Alamitos Energy Center

(13-AFC-01)

Data Responses, Set 6 (Response to Data Requests 83 to 168)

Submitted to
California Energy Commission

FIGURE 5.3-1R
Archaeological and
Historic Architectural Survey Area
 Alamitos Energy Center
 Long Beach, California
 December 2015

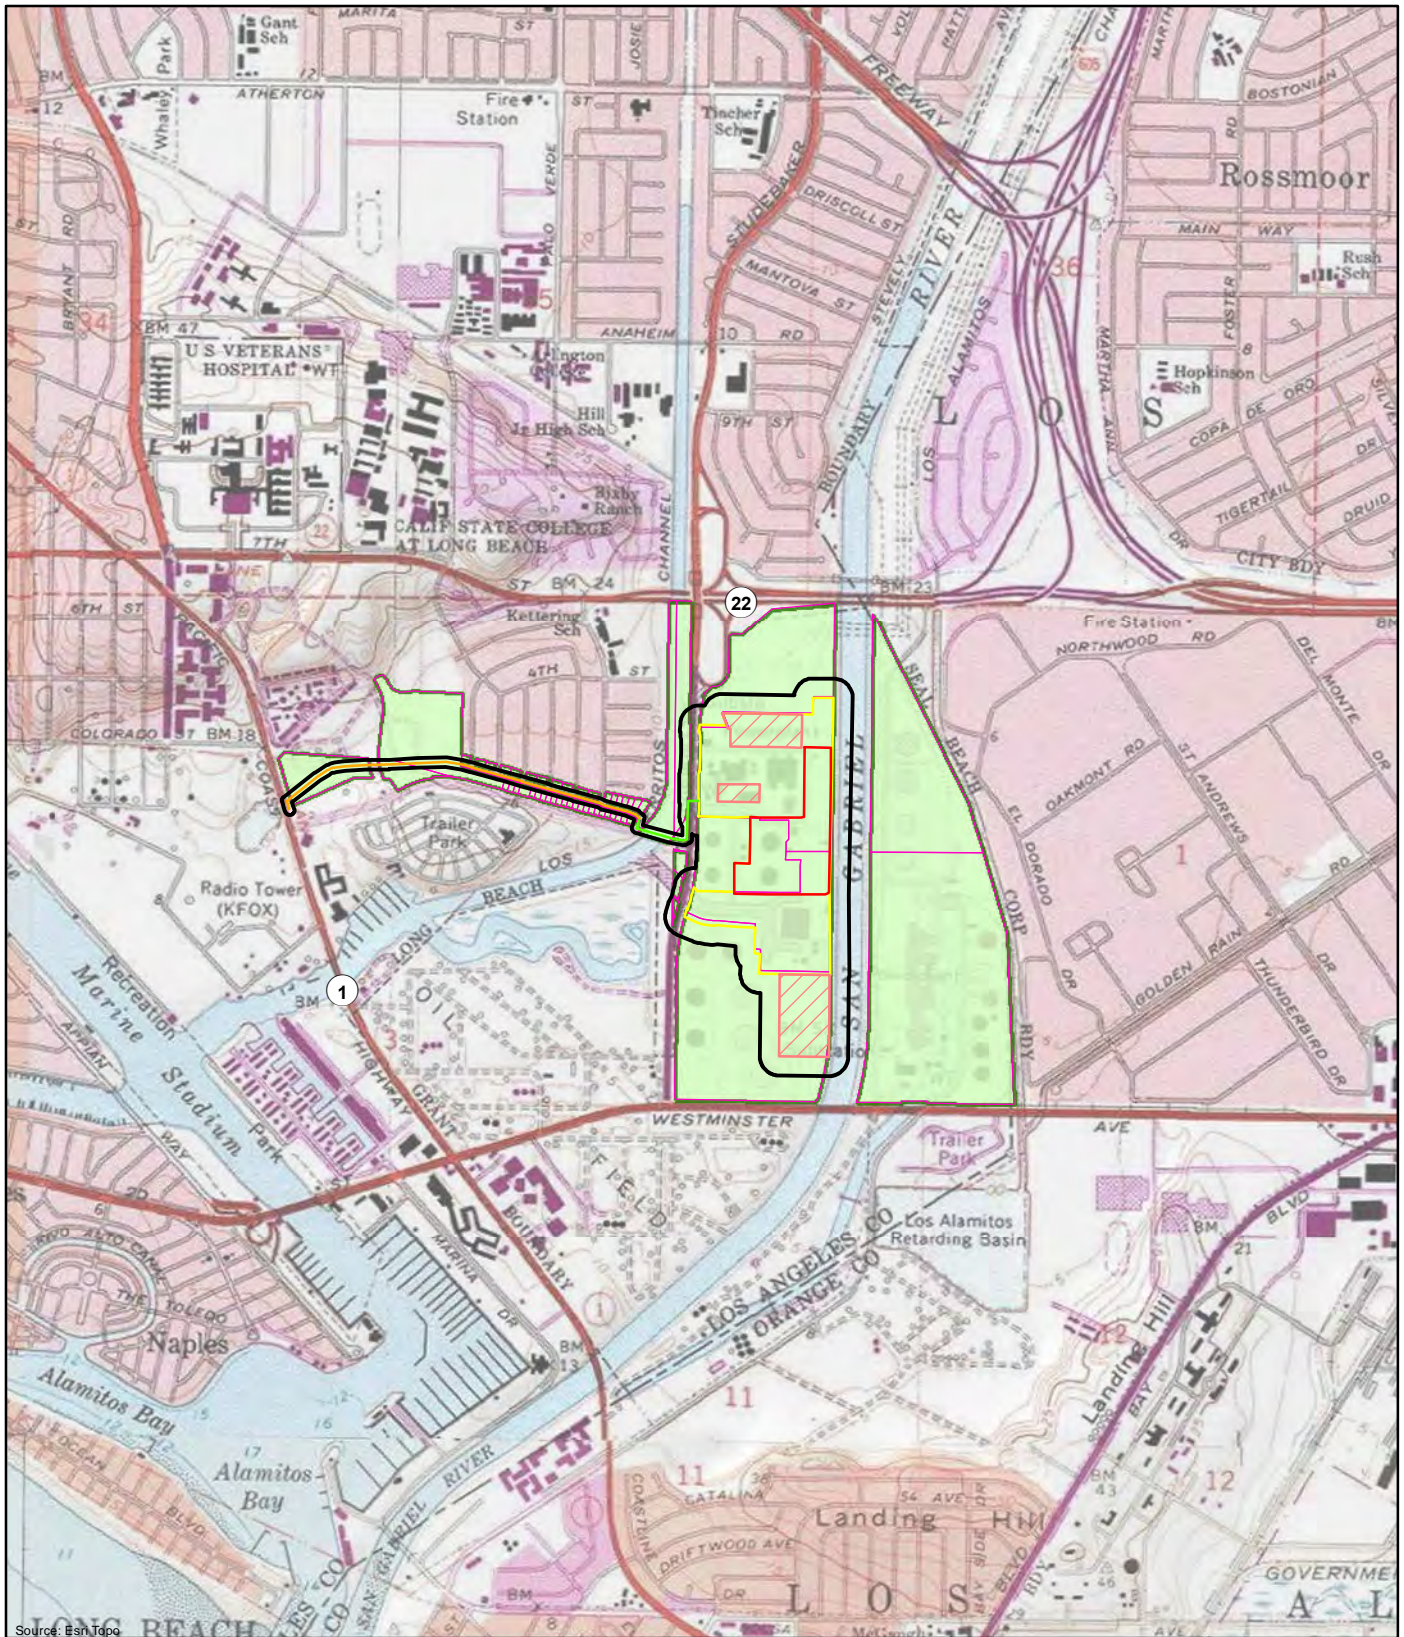
137. Provide a legend item for Figure 5.3-1 that identifies the limits of archaeological survey.

Response: Figure 5.3-1R presents the limits of the archaeological survey.

FIGURE DR153-1
AEC Operational Noise Contours
 Alamos Energy Center
 Long Beach, California
 December 2015

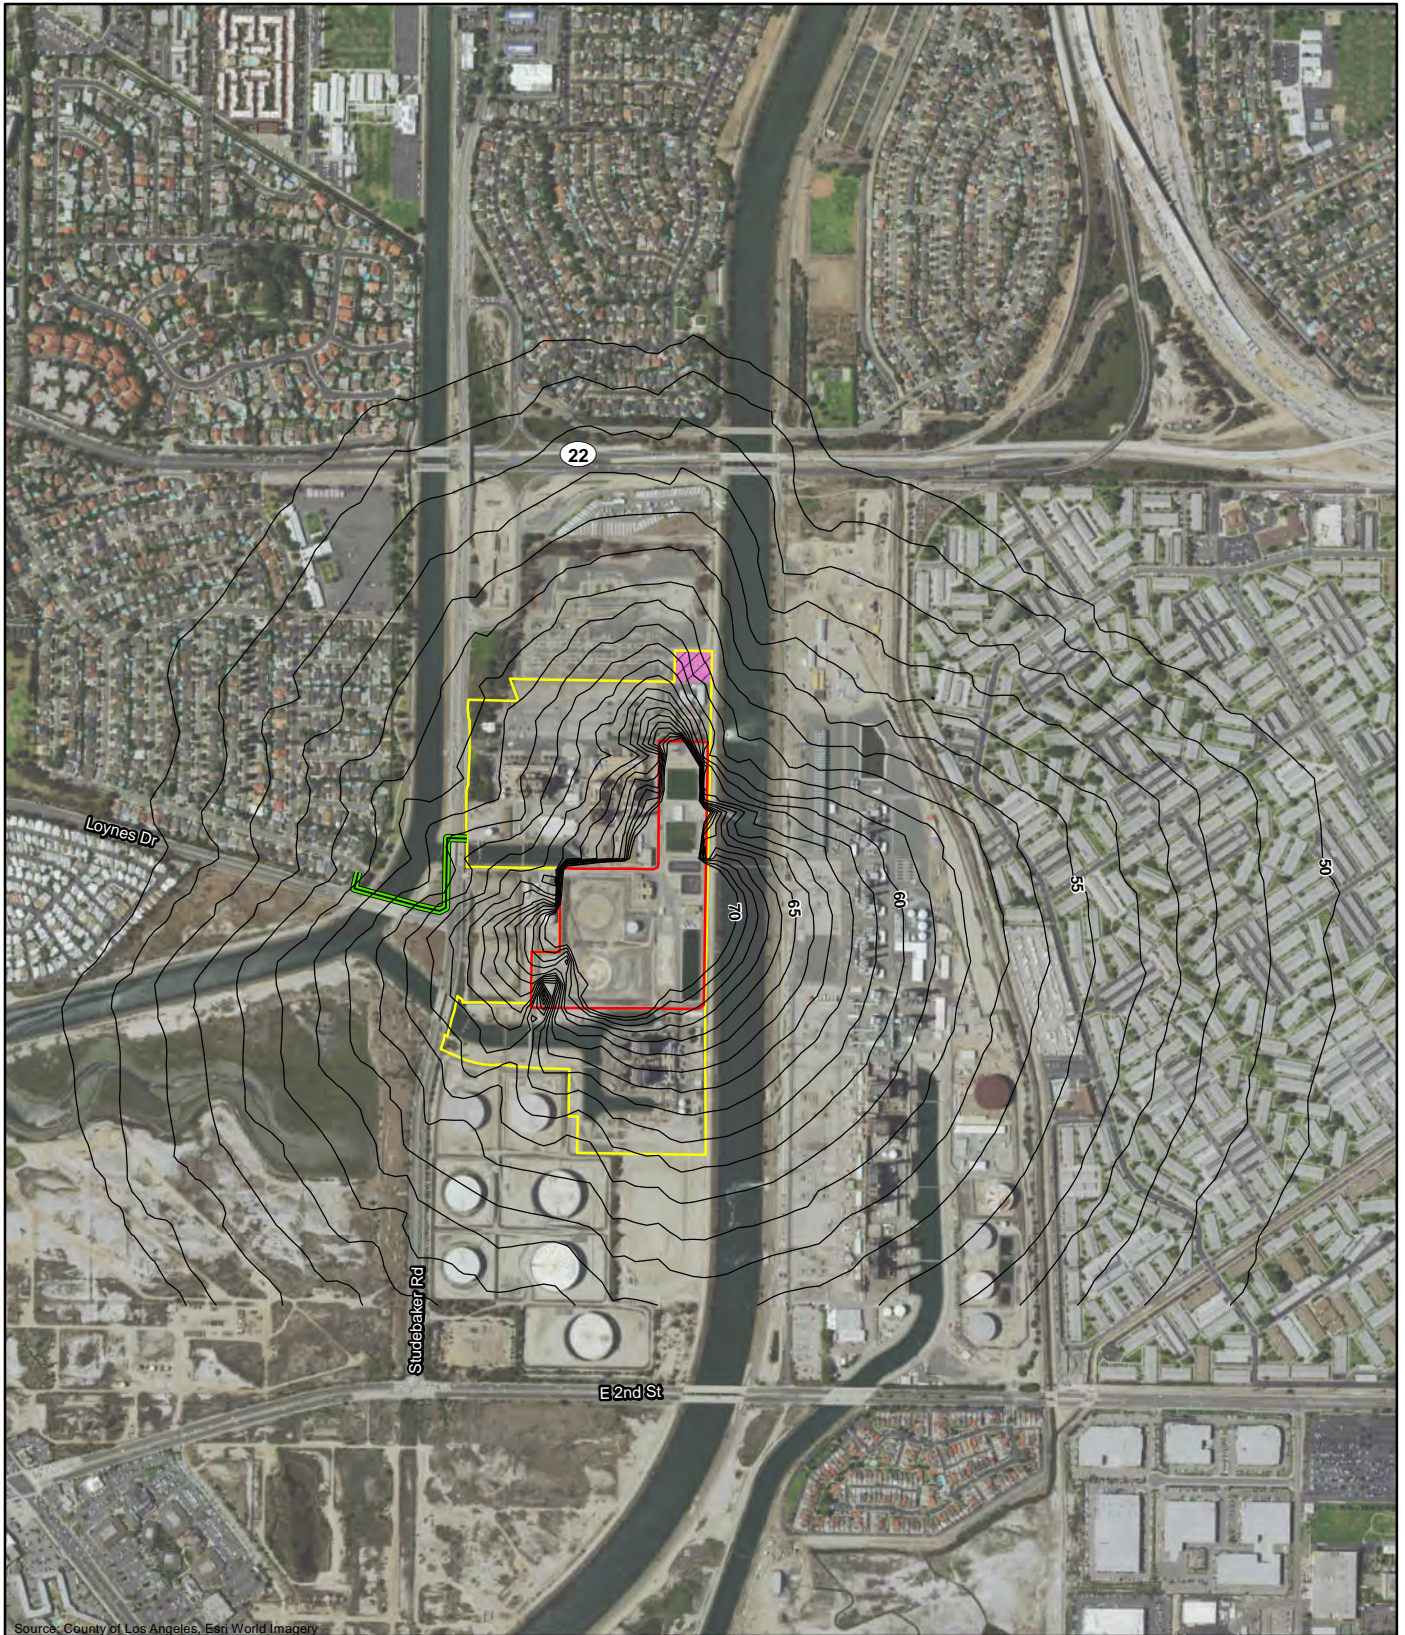
152. Please provide a modeling protocol that explains how the modeling was conducted, including a discussion of any assumptions made to conduct the modeling, such as ground absorption factors, meteorological data, and specifics on atmospheric propagation, wind directions, and sound shielding, and any other information that would help staff understand how the noise modeling was completed.

Response: The anticipated noise contours depicted in Figure DR153-1 reflect the preliminary modeling.
